EVALUATION OF TMI ACTION PLAN APPLICATION TO FORT ST. VRAIN  
Requirement I.D.2: Plant Safety Parameter Display Console

EVALUATION OF TMI ACTION PLAN APPLICATION TO FORT ST. VRAIN

EVALUATION OF TMI ACTION PLAN APPLICATION TO FORT ST. VRAIN

EVALUATION OF TMI ACTION PLAN APPLICATION TO FORT ST. VRAIN

Figure 1: Examples of Severe Accident Sequences for FSV Circulator Failure

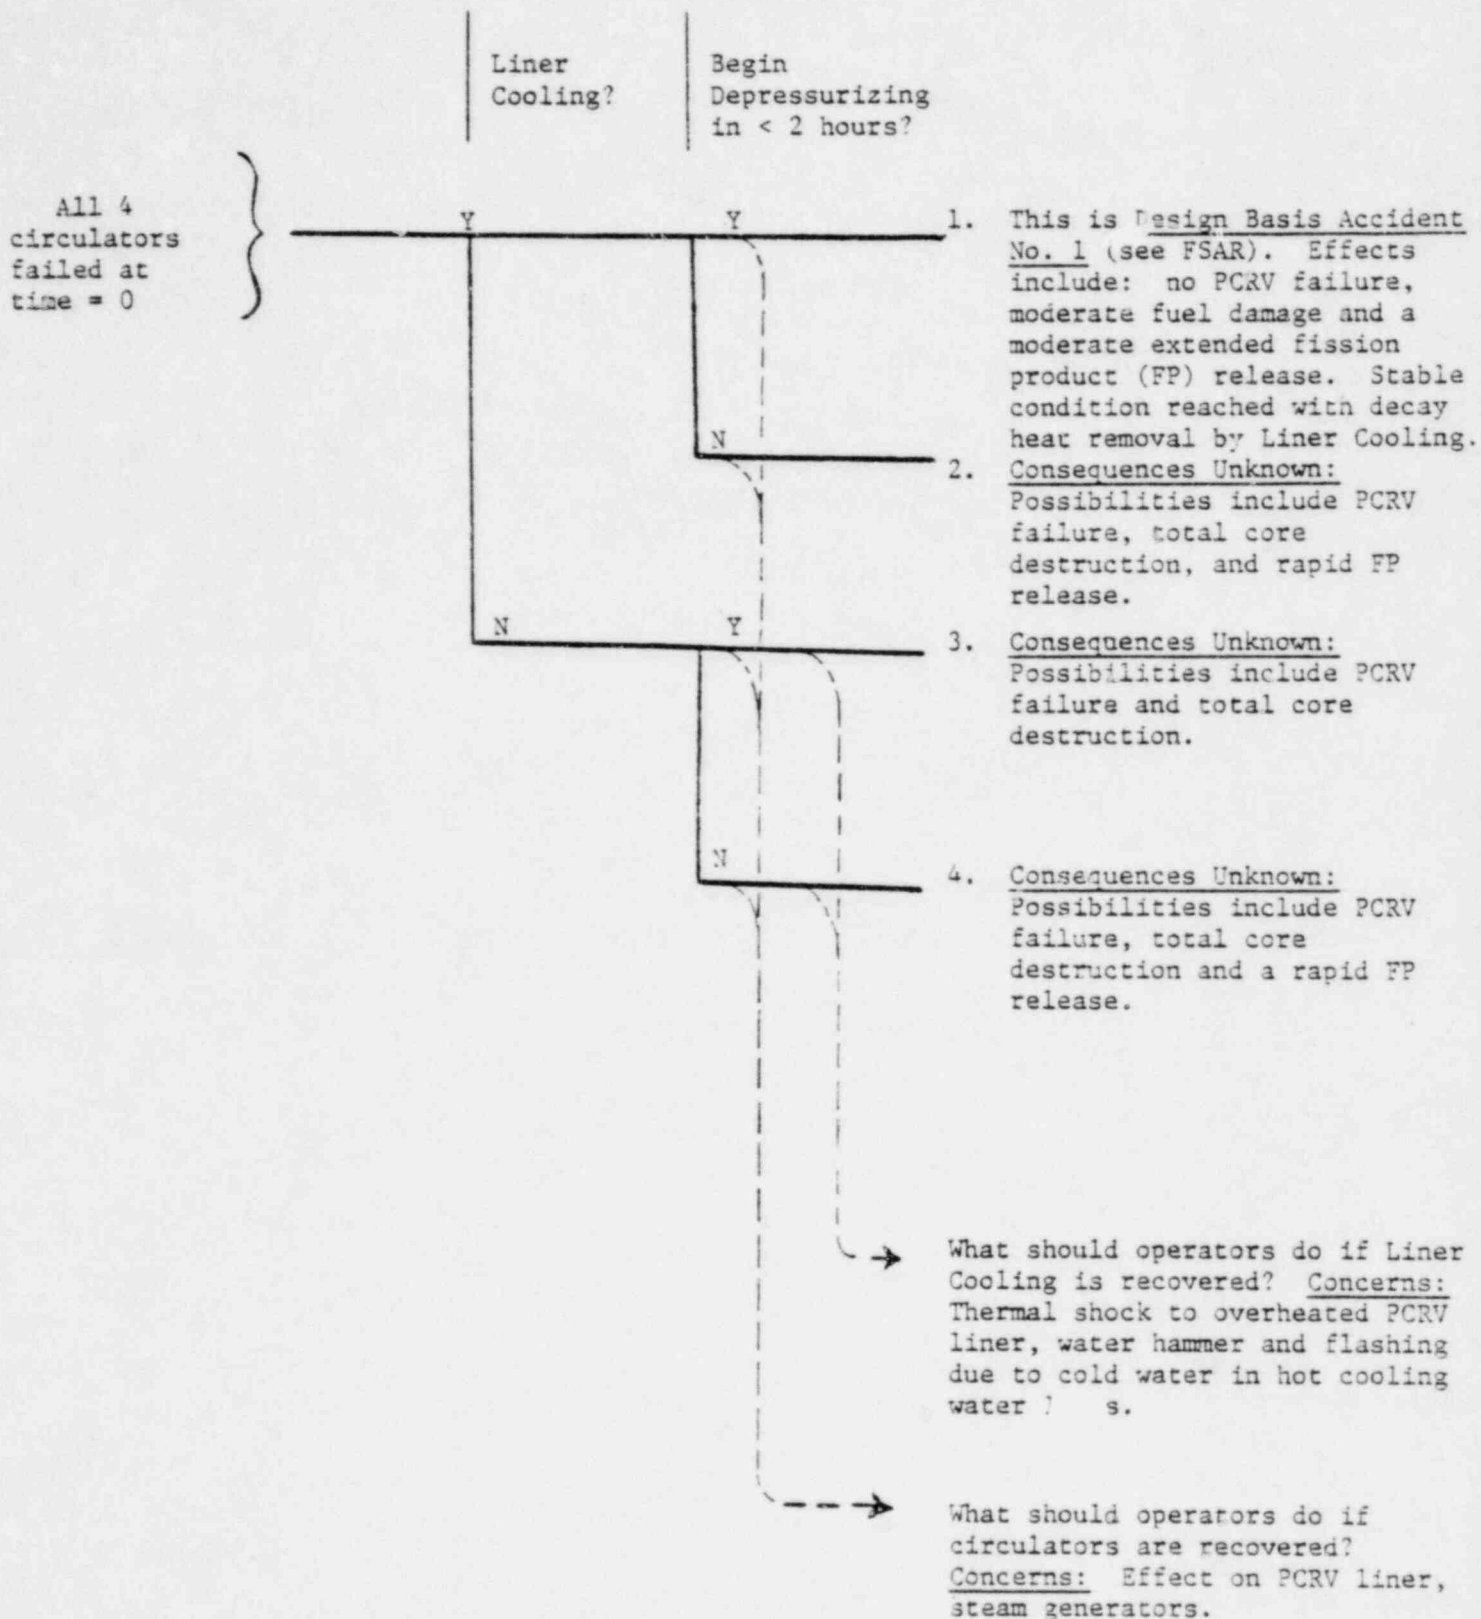
Sequences involving a postulated loss of all 4 circulators are shown in a very schematic fashion on Figure 1. The dominant sequence (No. 1) has already received considerable attention: it is Design Basis Accident No. 1 (DBA-1) and is fully discussed in the FSAR (as amended by PSC submittal P-77250 dated December 1977). When the circulators fail, the reactor trips, and the massive 27 ft. diameter by 23 ft. high reactor core begins to heat up in an approximately adiabatic manner. Figure 2 reproduces the fuel temperature vs time reported for DBA-1 in the FSAR. This figure is included here to illustrate the very slow rate of core temperature rise during unrestricted heatup. With respect to core heatup

Although the chance of severe accidents as shown on Figure 1 may be diminishingly small (especially for sequences 2,3, and 4), these are examples of the sequences that must be considered in the requirement for training for control and mitigation of degraded core accidents at FSV. The quantitative aspects of each major sequence must be investigated sufficiently such that time to reach various branch points is known, and temperatures of critical system components are known from best estimate computer analyses. For any given sequence written operational recommendations should be available concerning:

1. Desired (or likely) stable end condition
2. Recommended recovery strategy as a function of time when failed systems become available.

Fig. 2: Core Temperatures During Loss Of Forced Convection Accident (from Fort St. Vrain FSAR)

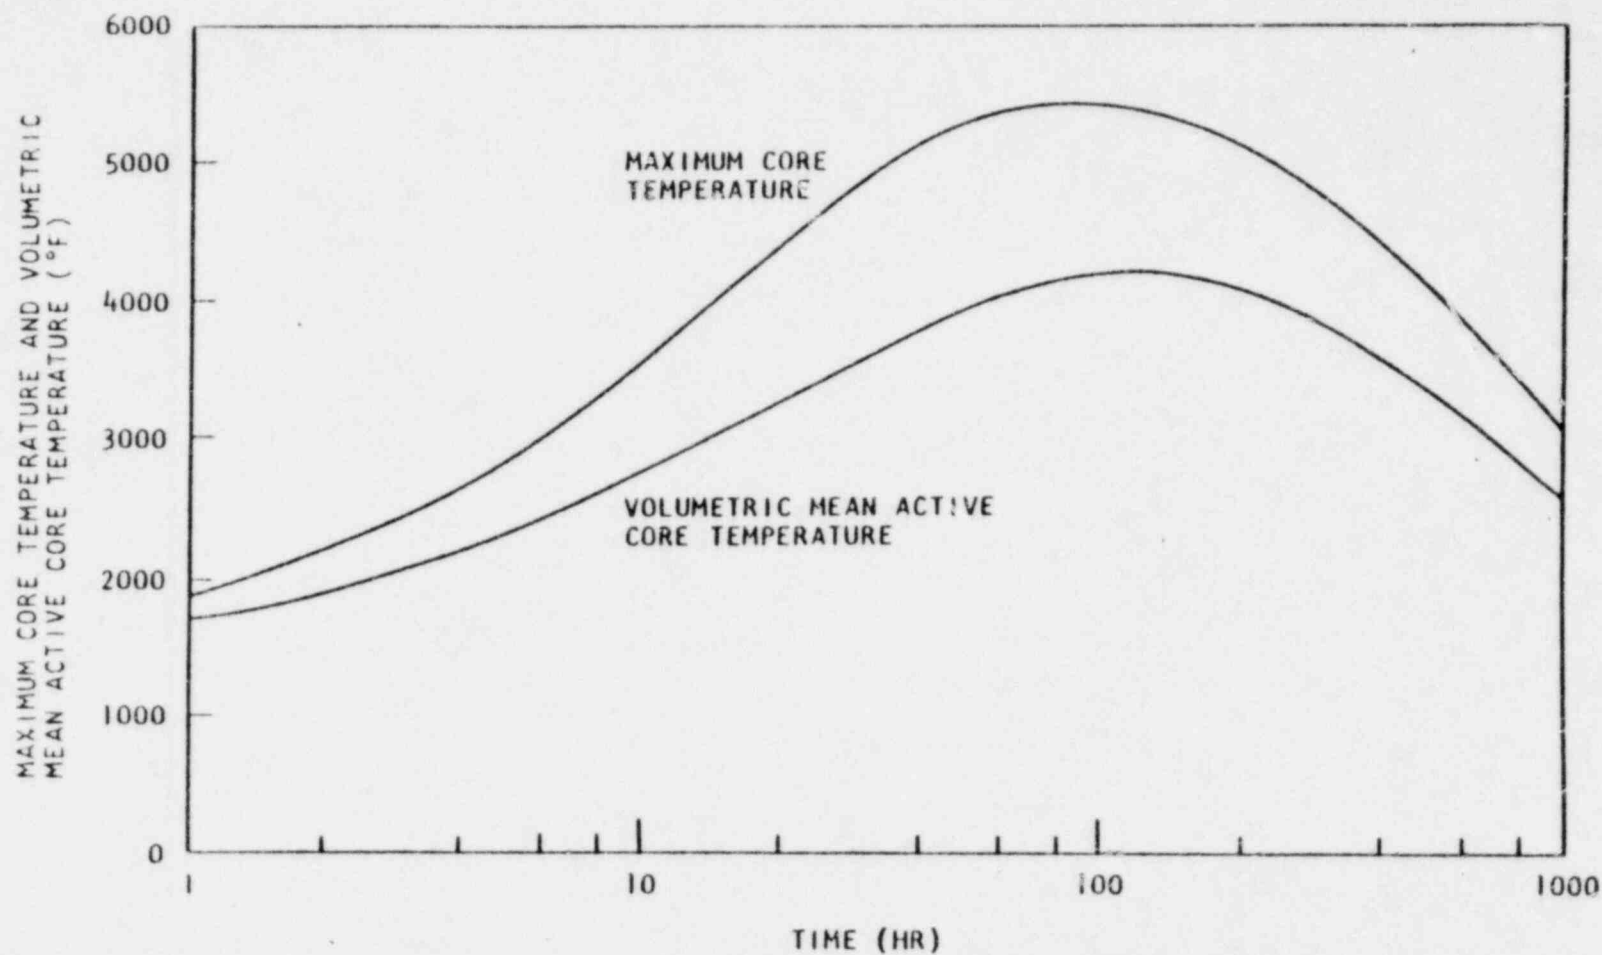
rate, the initial portion of Figure 2 would be applicable to all the sequences shown on Figure 1. Also shown by Figure 2 is the fact that the reactor can possibly reach a stable operating condition after DBA-1 without ever regaining the use of the circulators. Although the system was depressurized during the early part of DBA-1 to limit heat transfer to the liner, after about 100 hours the outer surface temperatures of the core are high enough such that radiant heat transfer directly to the liner exceeds the core heat generation rate, which by 100 hours is diminished by natural decay and by loss of volatile fission products (i.e. when temperature exceeded the 3100°F fuel particle coating rupture temperature). Liner cooling flow is assumed available throughout DBA-1. Radiological consequences of DBA-1 could be very light if the PCRV depressurization is completed before a significant number of fuel particles begin to rupture.
